# Attachment B to April 14, 2021 Notice of Violation

### COMPLIANCE EVALUATION INSPECTION REPORT

Sonoma County Water Agency  
Russian River County Sanitation District  
(Guerneville Collection System)  
800 Aviation Boulevard  
Santa Rosa, CA 95403

**Photo 10:** Maintenance log book for Main Lift Station. Many pages missing information (recorded in CMMS).

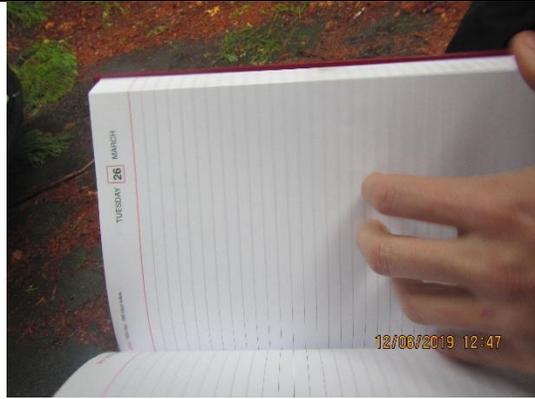
Orchard Avenue manhole and aeration basin overflows at the WWTF. Mr. McIntee next asked to review the maintenance logbook which was provided (**Photo 10**). Mr. McIntee observed that the logbook appeared to be missing entries (**Photo 11**) and inquired about this. We were told that collections operators mainly utilize digital records on computerized maintenance management software (CMMS) versus logging maintenance entries in logbooks.
